Submit 1 Copy To Appropriate District Office	State of New Mexico		ico	Form C-103			
District I - (575) 393-6161	Energy, Minerals and Natural Resources		Revised July 18, 2013 WELL API NO.				
1625 N. French Dr., Hobbs, NM 88240 <u>District II</u> – (575) 748-1283	OIL CONSERVATION DIVISION		30-025-44683				
811 S. First St., Artesia, NM 88210 <u>District III</u> – (505) 334-6178		ERVATION L outh St. Franc		5. Indicate Type of Lease			
1000 Rio Brazos Rd., Aztec, NM 87410		a Fe, NM 875		STA		<u> </u>	
<u>District IV</u> – (505) 476-3460 1220 S. St. Francis Dr., Santa Fe, NM 87505	Sano	a 1 c, 141vi 675	03	6. State Oil	& Gas Lease No.		
SUNDRY NO	TICES AND REPORT	S ON WELLS	D.	7. Lease Na	ame or Unit Agreem	ent Name	
(DO NOT USE THIS FORM FOR PROIDIFFERENT RESERVOIR. USE "APP PROPOSALS.) 1. Type of Well: Oil Well	POSALS TO DRILL OR TO LICATION FOR PERMIT" (FORM CONFOR	SUCH		ER 15 WA FEE		
	Gas Well Other	HO2 BJ	018	8. Well Nu

Flowmaster Fee 24 34 15 WA 6H

4-1/2" Permanent Tieback Installation Procedure

Flowmaster Fee 24 34 15 WA 6H **Wellbore Diagram**

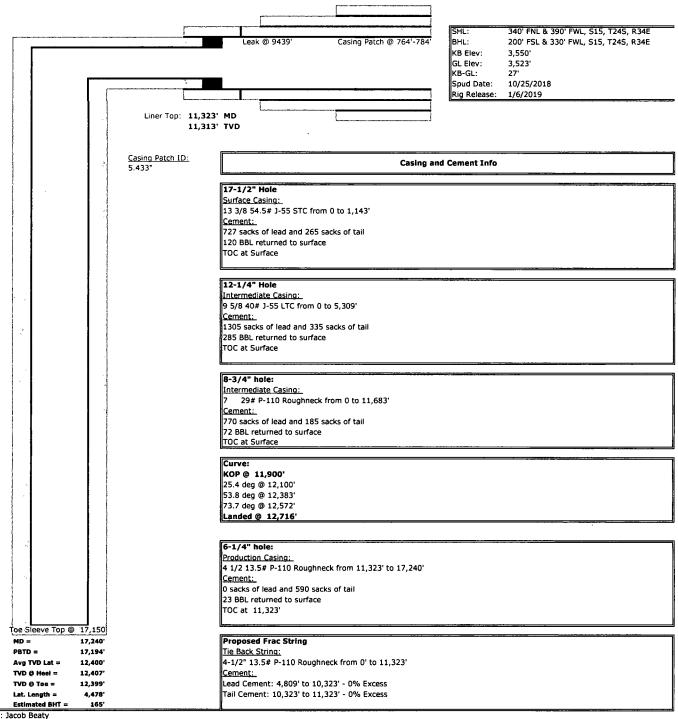
•		
	The Dreedure		THED.				
OTHER: Remediation Procedure OTHER: UTHER: U							
of starting any proposed work). SEE RULE 19.15.7.14 NMAC. For Multiple Completions: Attach wellbore diagram of							
proposed completion or r	ecompletion.				_		
Marathon Oil Permian LLC reque		manent Tieback In	stallation procedure	as discussed vi	ia telephone with the C	CD.	
Please see attached for procedur	e details.						
·.

- 1) Run in hole with liner tieback seal assembly and 4-1/2" 13.5# P-110 tieback string utilizing casing running crew and torque turn services.
- 2) Sting into liner hanger polished bore receptacle (PBR) and pressure test to 2000 psi to confirm seals
- 3) Unsting and pick up ~5-10' above PBR.
- 4) Pump cement job and displace cement out of tie back assembly.
- 5) Sting into PBR and land 4-1/2" tieback string in wellhead. Pressure test to 2000 psi to confirm seals on PBR.
- 6) Install 7-1/16" 10M x 7-1/16" 10M wellhead section (see wellhead schematic).
- 7) Wait on cement.
- 8) Resume completions operations.
